Herefordshire Local Plan

Hereford Area Plan

Housing and Employment Site Options Consultation

Technical Site Assessments - Central Hereford

Cen28

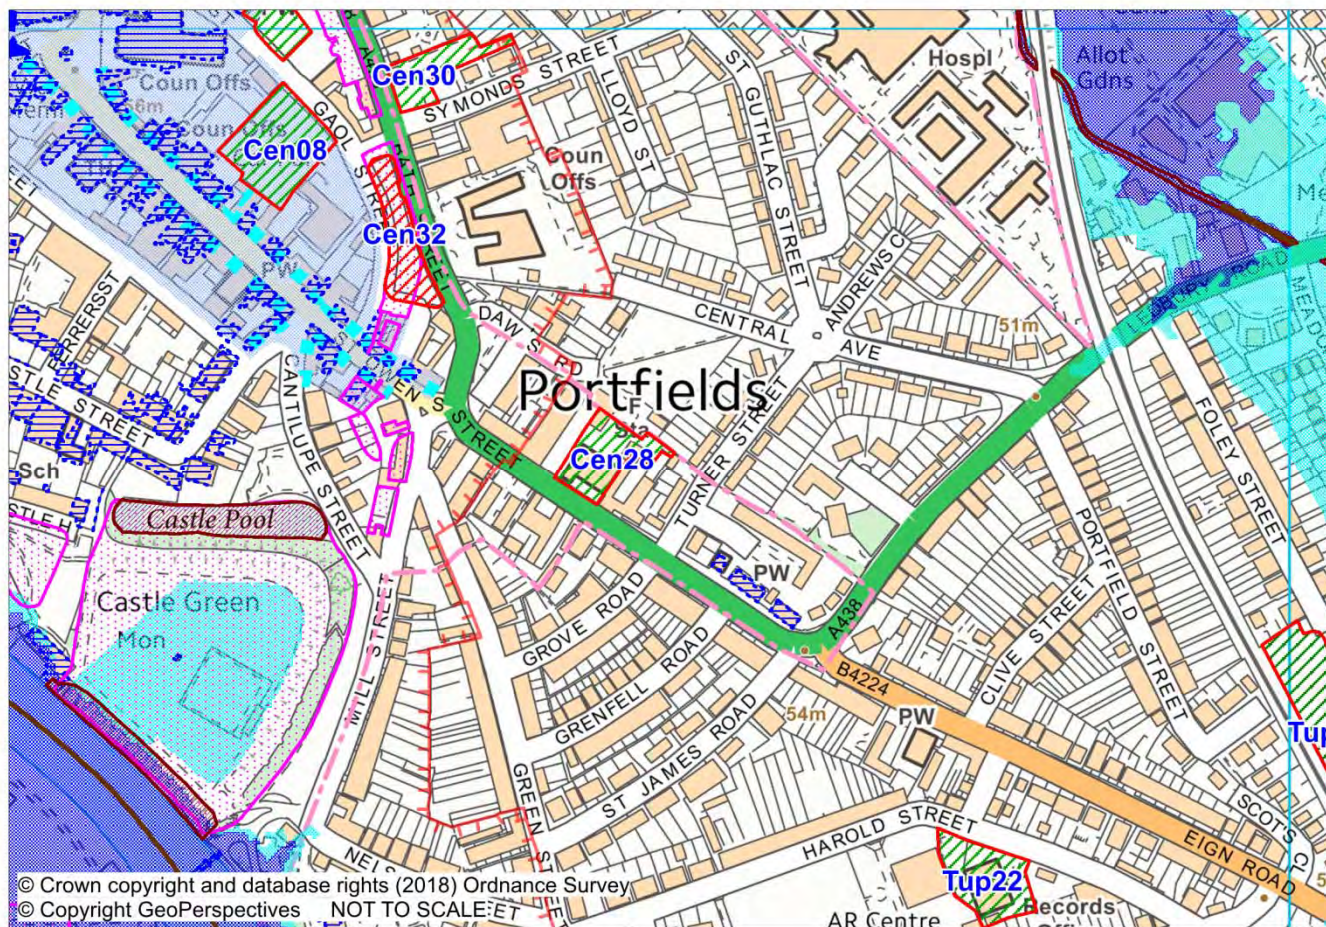
HC Highways comments
Public Transport accessibility comments
<i>Are standards for access to local services likely to be achievable?</i> Yes. Close to city centre location and bus stops.
Access comments
Existing access onto St Owen Street could be amended to serve the development. Rear access is narrow but could potentially be used for some of the development or for pedestrian/cycle access.
Local network comments
<i>Any capacity concerns on this section of the network?</i> Some capacity issues in the peak hours/late afternoon in the vicinity. Existing use would be offset in Transport Statement/Assessment.
Site dependence on Hereford Transport Package
HTP may provide additional capacity. Downgrading of Blueschool Street may have an adverse effect.
Mitigation measures
Secure cycle storage provision. Reduced car parking provision.
Highway site support
Subject to network capacity, development of the site would be supported.

HC Conservation comments
Built conservation
The site is on the outer edge of the Hereford Conservation Area. Any proposed development should consider the impact upon the setting of the conservation area and respond to the immediate context in a positive way.
Archaeology
Likely to be suitable. Although this brownfield site is - just - within the designated AAI, current information (which is likely in this case to be reliable) suggests that it has only moderate potential for archaeological finds of substance. Accordingly, reasonable proposals here are likely to be supportable under NPPF Para 141 and Core Strategy LD4. There may be a need for some limited archaeological recording as mitigation.
Biodiversity/Ecology
HRA – River Wye SAC/SSSI All foul water should be managed through connection to main sewer network. Confirmation that this is possible and also acceptable to Welsh Water is necessary. No direct discharge of any foul water outfall from any onsite treatment system in to any watercourse or culvert will be considered acceptable. All surface water will need to be managed on site through a Sustainable Drainage system (SuDS).

Open Space requirements
<i>For assessment if appropriate</i>
Development Management
On the assumption that relocation is feasible there would be no objection in principle to the allocation of this site for residential redevelopment within the HAP.

Conclusion			
<p>This site is the current fire station for Hereford but the service is looking to relocate making the site available for other uses. The site mainly comprises of buildings and its environs are primarily residential including an adjacent garage and a public house opposite. Access to the site is possible via St Owen’s Street for vehicles and the rear of the site for non-vehicle use.</p> <p>Although the site is located within the designated Area of Archaeological Importance, current information suggests that it has only moderate potential for archaeological finds. There may be a need for some limited archaeological recording as mitigation, but this should not prevent the site coming forward. The conservation area is nearby and any proposed development should consider the impact upon the setting of the conservation area and respond to the immediate context in a positive way.</p> <p>If a suitable site for a new fire station can be found then this site could be suitable for redevelopment.</p>

Cen30

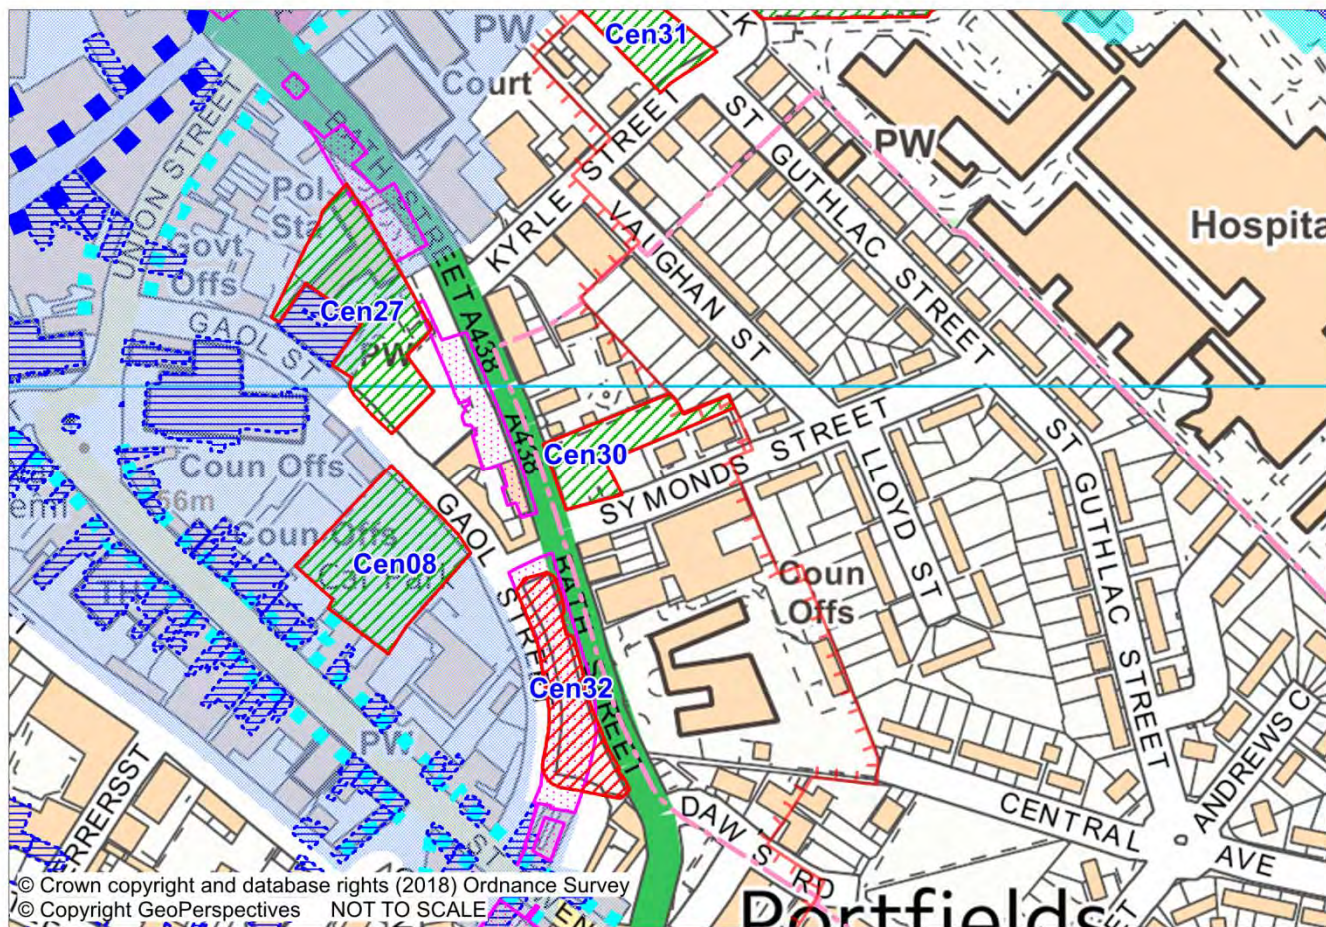
HC Highways comments
Public Transport accessibility comments
<i>Are standards for access to local services likely to be achievable?</i> Yes. Close to city centre location and all facilities and very accessible.
Access comments
Access would be to Symonds Street. Due to the shape of the site and projection behind the adjacent building, an awkward site to develop unless that building is included in the site. A single point of access to a parking area to the rear or underneath would be preferred. Reduced car parking provision may be applicable, but that would be dependant on size and number of units proposed. Secure covered cycle storage should be provided.
Local network comments
<i>Any capacity concerns on this section of the network?</i> Bath Street/Commercial Road/Blueschool Street/Newmarket Street has capacity issues in peak hours and through late afternoon. A Transport Assessment would be required to assess the impact of the development on the network, and as with all HAP sites the scope and developments to be considered will need to be confirmed. Existing traffic generation of car park would be offset.

Site dependence on Hereford Transport Package
HTP may create more capacity on roads to the west, but possible downgrading of Blueschool Street may have implications.
Mitigation measures
Reduced car parking, secure covered cycle storage provision.
Highway site support
The loss of car parking would need to be looked at overall with other sites and in conjunction with the council's car parking policy and review. Also residents use the car parks overnight. If the loss of car parking was considered acceptable, then the site would be supported.

HC Conservation comments
Built conservation
Development is not precluded on grounds of built Heritage Assets. However any development should preserve or enhance the character and appearance of the conservation area.
Archaeology
May possibly be suitable, subject to good quality design, and acceptable assessment and evaluation under NPPF Para 128. Although just outside the designated AAI and City Walls SAM, this is still a sensitive site, and there may be some appreciable challenges as regards any wholesale development. It would be particularly important here to avoid undue harm to the setting of the SAM, and to avoid the creation of a new, visually damaging Bath Street

'canyon' between this site and the existing flats off Gaol Street. On balance, with careful design (which may include some loss of land on the frontage to provide a suitable buffer) it should be possible to arrive at an appropriate solution.

As regards the potential issue of previously undiscovered *below ground* archaeology, this site is – given its location – perhaps of lesser potential than other city centre sites, although there is still an appreciable risk of significant remains being present. There is a good case here for undertaking some early field evaluation to give an initial heads up in this respect. If the potential for below-ground remains was demonstrated to actually be quite low, then a relatively straightforward avenue to some development might thereby be opened.

A sensitive development of a scale that reflects Venns Close, rather than the four storey apartments to the west, would be acceptable here. As with other city centre/edge of centre car parking sites (Gaol Street and Bus Station to name two), consideration will have to be had to the loss of provision.

The site is a flat public car park. It is situated within the Conservation area. The City Walls Scheduled Ancient Monument (SAM) lies opposite to the west. There are two educational related buildings in use close to the site fronting on to Symonds Street. Venns Close mews is situated to north which has particular architectural interest (chimney pots) from the Arts & Craft era, St Owens Centre to south, suburban interwar housing to north east and east. To the west, on the opposite side of Bath Street, is the apartment development attached to the John Haider (Venn) building.

Although just outside the designated AAI and City Walls SAM, this is still a sensitive site, and there may be some appreciable challenges as regards any development. It would be particularly important here to avoid undue harm to the setting of the SAM, and to avoid the creation of a new, visually damaging Bath Street 'canyon' between this site and the existing flats off Gaol Street.

The site has potential for significant archaeological remains and would only be acceptable if evaluation work was undertaken to assess this possibility. A sensitive development of the site could be acceptable if all investigations are carried out to ascertain the site's historical value. Loss of the car park would also need to be acceptable to the car parking strategy for the city.

Cen31

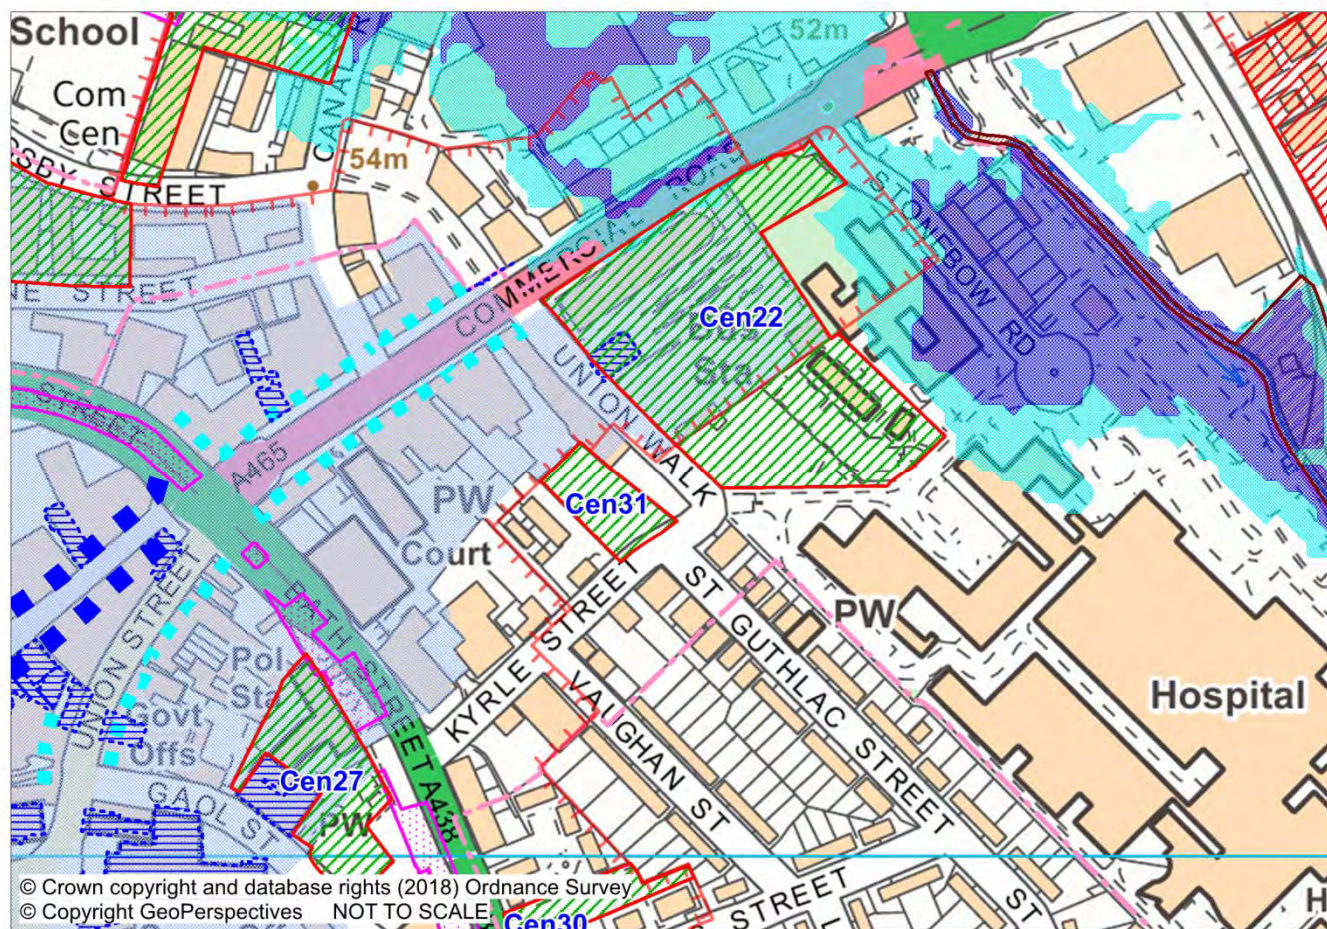
HC Highways comments
Public Transport accessibility comments
<i>Are standards for access to local services likely to be achievable?</i> Yes. Close to city centre location.
Access comments
Access could be achieved onto Union Walk/Kyrle Street to suit development. Reduced car parking provision may be appropriate, depending upon numbers and size of units. Secure covered cycle parking should be provided.
Local network comments
<i>Any capacity concerns on this section of the network?</i> There are capacity concerns in the area at peak times but existing car park use would be offset in comparing network impact.
Site dependence on Hereford Transport Package
Probably not as brownfield site.
Highway site support
Subject to satisfactory transport comparison, site would be supported. Loss of car parking needs to be considered overall with other potential car park losses.

HC Conservation comments
Built conservation
The site is on the edge of the Hereford Conservation Area. This would be a consideration for any application. Any proposed development should preserve or enhance the character and appearance of the Conservation Area.
Archaeology
May be suitable, subject to acceptable assessment and field evaluation under NPPF Para 128. This fair - sized site is within the designated AAI, and may potentially have a link with the lost medieval monastic site of St Guthlac's (generally thought however to be located further to the east). There would appear to be no real above ground issues of substance, but there are some risks of below ground remains of interest being present in parts of the site.
Biodiversity/Ecology
HRA – River Wye SAC/SSSI All foul water should be managed through connection to main sewer network. Confirmation that this is possible and also acceptable to Welsh Water is necessary. No direct discharge of any foul water outfall from any onsite treatment system in to any watercourse or culvert will be considered acceptable. All surface water will need to be managed on site through a Sustainable Drainage system (SuDS).

Development Management
Parking strategy permitting, development of this site would be acceptable in principle. It appears, however, that it would be very difficult to deliver significant numbers on this site in isolation and it should be established whether the adjoining landowner would be prepared to bring forward their car park simultaneously in order that a more workable parcel can be delivered. However, car parking might be the more attractive long-term revenue stream.

Conclusion
<p>This site is a small privately owned car park with a very small council owned car park next door. The surrounding land uses are mainly residential with the hospital land close by.</p> <p>This site is within the designated AAI, and may potentially have a link with the lost medieval monastic site of St Guthlac's (generally thought however to be located further to the east). There would appear to be no real above ground issues of substance, but there are some risks of below ground remains of interest being present in parts of the site. The site could be acceptable once an assessment and field evaluation is carried out. The site is on the edge of the Hereford Conservation Area therefore any proposed development should preserve or enhance the character and appearance of the Conservation Area. Access to the site could be achieved.</p> <p>If the site is available then it could be identified in combination with the council owned car park to be developed as one site. The parking strategy for council owned car parks must be established as to whether the loss of the car park next door is acceptable. The site will need to be discounted if not available.</p>

Cen32

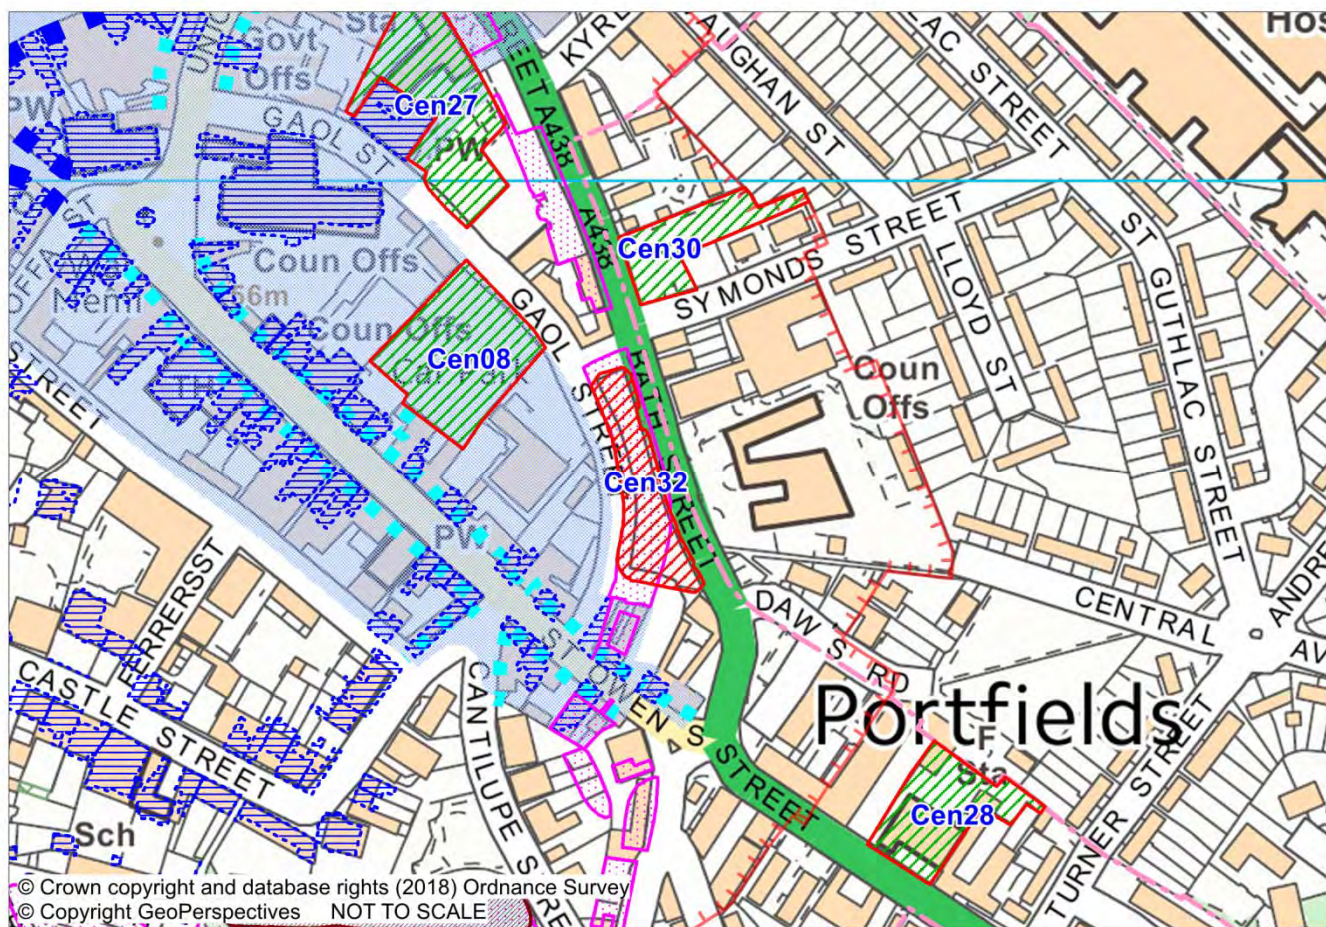
HC Highways comments
Public Transport accessibility comments
<i>Are standards for access to local services likely to be achievable?</i> Yes. Close to city centre, bus and train station with good connectivity.
Access comments
Due to narrowness of Gaol Street , a single point of access from Bath Street is likely to be the only option acceptable, suitably located away from the pedestrian crossing and the access to Bath Street offices development opposite. Parking would likely to be provided below development whilst providing a frontage to Bath Street. Level difference to Gaol Street to overcome and lack of footway along Gaol Street to be addressed.
Local network comments
<i>Any capacity concerns on this section of the network?</i> Bath Street/Commercial Road/Blueschool Street/Newmarket Street has capacity issues in peak hours and through late afternoon. Existing car park use would need to be offset to assess the overall network implications of the development. A Transport Assessment may be required to assess the impact of the development on the network, and as with all HAP sites the scope and developments to be considered will need to be confirmed.

Site dependence on Hereford Transport Package
HAP may create more capacity on roads to the west, but possible downgrading of Blueschool Street may have implications.
Mitigation measures
HTP. Reduced parking provision may be appropriate in this location, depending on size and numbers of units. Secure covered cycle storage should be provided.
Highway site support
The car park provides an important part of the overall car parking provision in Hereford, being to the east of the city centre and is very well used. The loss of car parking would need to be looked at overall with other sites and in conjunction with the council's car parking strategy. Also residents with season tickets can use the car parks overnight. If the loss of car parking was considered acceptable, subject to adequate network capacity, site would be suitable and supported.

HC Conservation comments
Built conservation
The site is a SAM within the Herefordshire Conservation Area. Historic England would be the main contact with regard the setting of the SAM and any alteration to it. If development is not precluded, our comments would be that there should not be development on the area of the former ditch and that any development should be on the inner side of the former city wall. Any proposals should preserve or enhance the character and appearance of the conservation area.

Archaeology
<p>Not likely to be at all suitable. This site is exceptionally sensitive and would be extremely challenging to develop from a historic environment point of view. Fully within the Hereford AAI, and almost entirely scheduled under the 1979 Ancient Monuments and Archaeological Areas Act, there would normally be a strong presumption against development here, it being very difficult to develop the site without causing harm of substance.</p> <p>The current open aspect of the site provides one of the best medium distance views of the historic city's heritage assets and their layout that Hereford possesses, and the loss of this should not lightly be contemplated. There is also potentially a major below-ground issue in that intact city wall, and an appreciable length of associated city ditch, would be directly impacted.</p>
Biodiversity/Ecology
<p>HRA – River Wye SAC/SSSI</p> <p>All foul water should be managed through connection to main sewer network. Confirmation that this is possible and also acceptable to Welsh Water is necessary. No direct discharge of any foul water outfall from any onsite treatment system in to any watercourse or culvert will be considered acceptable. All surface water will need to be managed on site through a Sustainable Drainage system (SuDS).</p> <p>Protected Species (in line with NPPF, NERC Act, Core Strategy LD1-3)</p> <p>ANY demolition of existing building or structure or significant site clearance of vegetation will trigger a requirement for an Ecological Survey.</p>

Conclusion			
<p>This site is currently a well-used city centre car park. This is an exceptionally sensitive site and would be extremely challenging to develop from a historic environment point of view. Fully within the Hereford AAI, and almost entirely scheduled under the 1979 Ancient Monuments and Archaeological Areas Act, there would normally be a strong presumption against development here, it being very difficult to develop the site without causing harm of substance. Therefore due to the exceptional archaeological sensitivities, this site is considered unsuitable for further consideration as an Option Site.</p>			
Evidence of site availability	Yes	Information source	Council owned land
Suitable for employment land	No
